One Mile Lift Station and Egbert Street Force Main

ADDENDUM

ADDENDUM NO: 3

TENDER NO: 2022-19

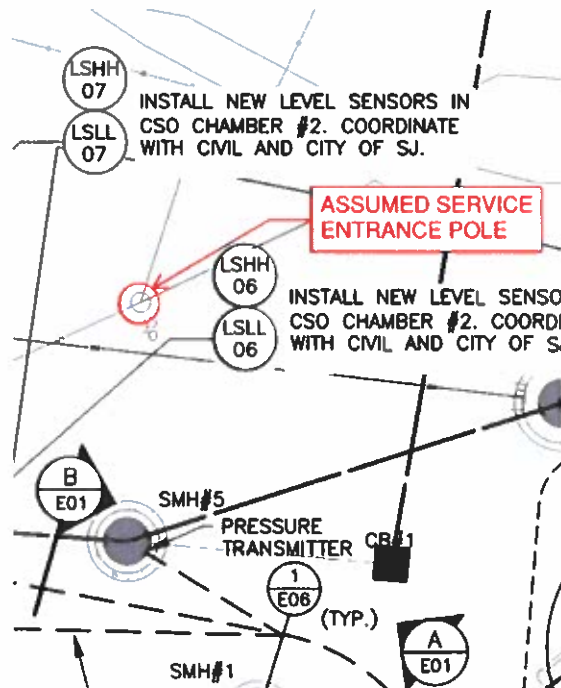
Q3. Where will the new SJE pole be located, relative to the new transformer (to determine primary duct length)?

A3. Pole location yet to be coordinated with Saint John Energy. For tendering purposes, assume the service entrance pole is the guy pole located just west of SMH#5, pictured below:
